**Subject: Fort Monmouth, NJ
ECP Phase 2 Site Investigation Parcel 28 Site**

RE: Draft Site Investigation Report
Fort Monmouth, NJ

NJDEP COMMENTS on
SITE INVESTIGATION REPORT
FORT MONMOUTH, NJ

Parcel 28 - Former Eatontown Laboratory

Figure 1
Fort Monmouth
Finding of Suitability To Transfer
Parcel E Property Information

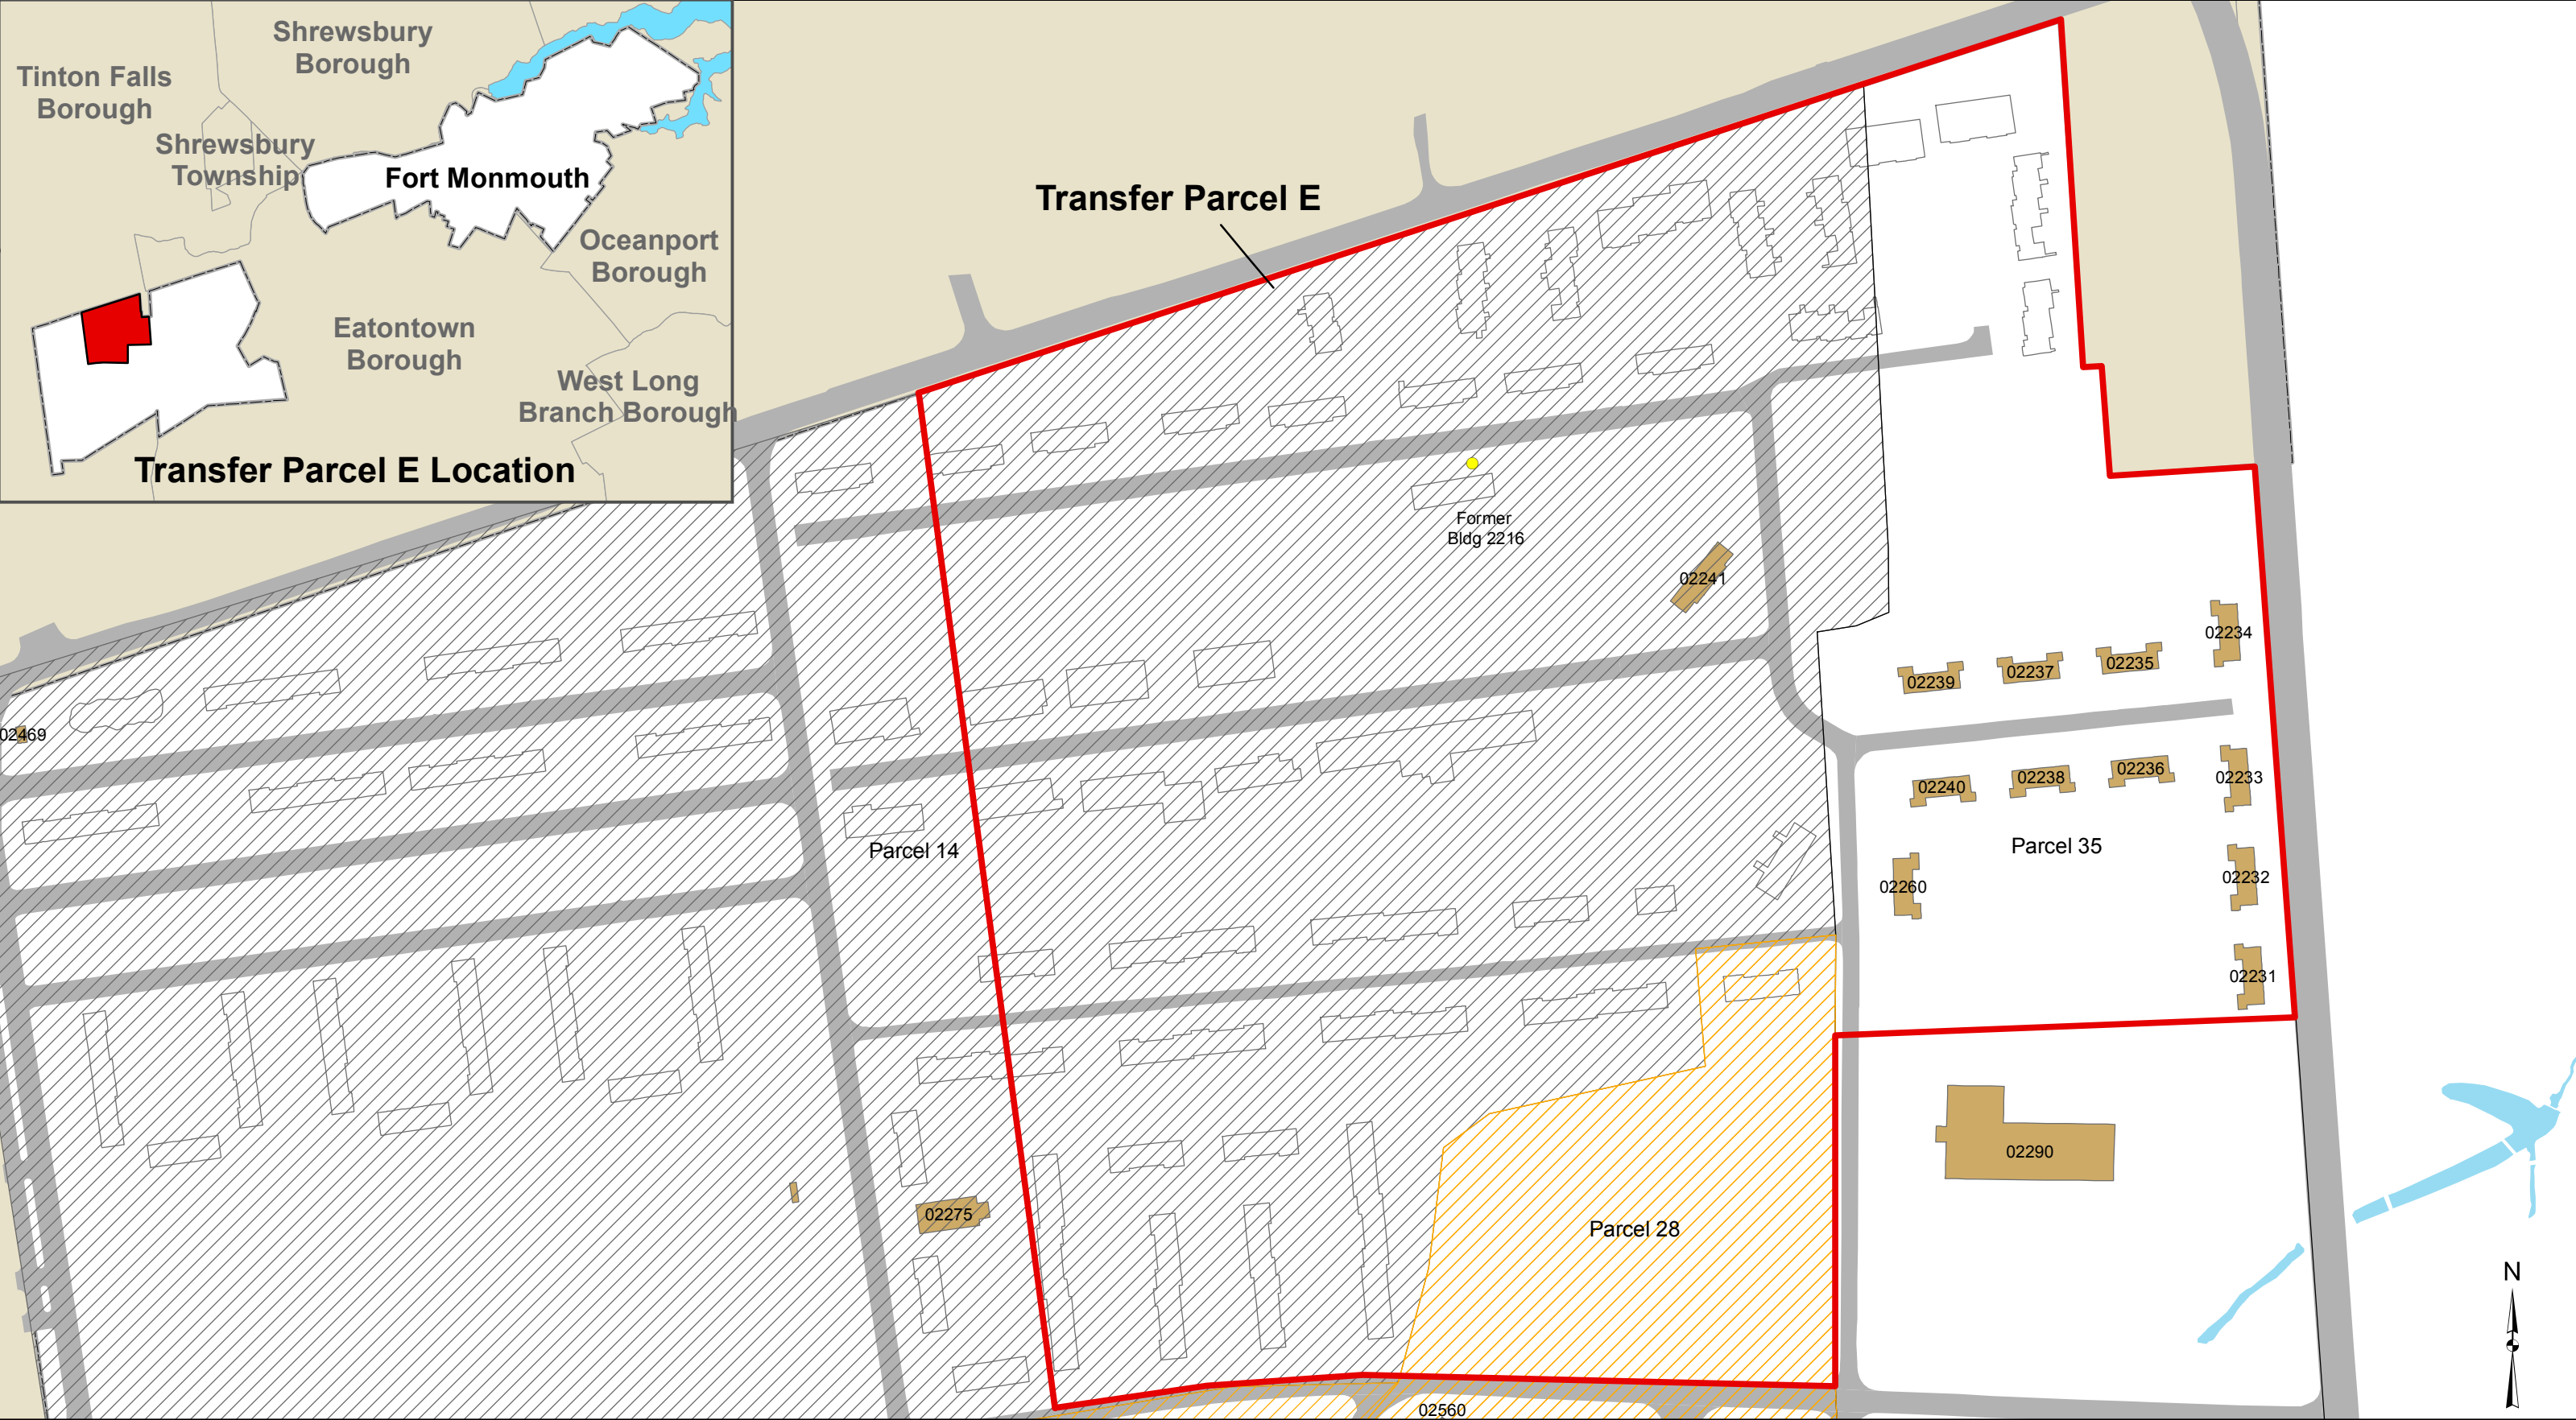
The Army is in the process of preparing the required documentation to support the transfer of a portion of Fort Monmouth Charles Wood Area (CWA) known as Parcel E (see attached map) to the Fort Monmouth Economic Revitalization Authority (FMERA). Per the Army's request, CALIBRE Systems, Inc. (CALIBRE) has prepared this letter to provide the New Jersey Department of Environmental Protection (NJDEP) with a response to an open item from the U.S. Army BRAC 2005 Site Investigation Report Fort Monmouth, Final July 21, 2008 that is associated with Parcel E. The Site Investigation (SI) report is also referred to as the Environmental Condition of Property (ECP) Phase II as the investigation work in the SI was performed to support the evaluations completed in the U.S. Army BRAC Environmental Condition of Property (ECP) Report, Fort Monmouth, Monmouth County, New Jersey, January 29, 2007.

Of the four soil samples collected in this area there was only one detection of a compound above the Residential Direct Contact Soil Remediation Standard (RDCSRS). This was for arsenic at soil boring location P28-SB3 (at a depth of 5.5 feet). The result was 20.7 mg/kg which is only

slightly above the RDCSRS of 19 mg/kg. This level is also lower than the site specific background level of 31.6 mg/kg identified in the Site Inspection report prepared by Weston in 1995. Arsenic is also a component of the glauconitic soils found in the area of Fort Monmouth and would indicate a natural source of this metal. It is also noted that there is no likely direct contact hazard from soil at this depth. Therefore the Army requests that the NJDEP approve a No Further Action for soils in this area of Parcel 28.

To investigate groundwater in this area the Army collected one groundwater grab sample from a geoprobe boring in the SI. The only analyte to exceed the Ground Water Quality Standard (GWQS) was aluminum. Aluminum was detected at a concentration of 500 parts per billion (ppb) versus a GWQS of 200 ppb. The site specific background level for aluminum in groundwater as developed in the Weston SI was 8,210 ppb. As discussed in the 1995 Weston Site Investigation Report, several natural and anthropogenic factors contribute to the wide range in concentrations of metals in soils, which further impact the concentrations of metals in groundwater. Soils derived from glauconitic sands contain abundant aluminum, calcium, potassium, iron, magnesium, manganese, and sodium (among others), which are likely to be present at elevated concentrations in the groundwater, particularly when sediments are entrained in the collected groundwater sample. The aluminum observed is also likely influenced by the nature of the sample collection method (i.e. sample was turbid due to collection from geoprobe boring). Due to the low level of exceedence, the likely turbidity issue and the fact that the level observed at this location was well below the background level, the Army requests NJDEP approve a No Further Action for groundwater in this Area of Parcel 28.

In order to support the property transfer the Army will be revising the property classification for this area of Parcel 28 only. The entire Parcel 28 was originally classified as Category 7, "Areas that have not been evaluated or require additional evaluation." Based on the sampling results that do not indicate a release in the area of Parcel 28 within transfer Parcel E, the Army is proposing to reclassify this part of Parcel 28 only as a Category 1, "Areas in which no release or disposal of hazardous substances or petroleum products have occurred (including no migration of such substances from adjacent areas) and a visual inspection indicates that both the land and the buildings are uncontaminated". The remainder of Parcel 28 will remain a Category 7 until the additional investigation and if needed remedial actions are completed. The Army requests NJDEP's concurrence in the Category 1 designation for this area.
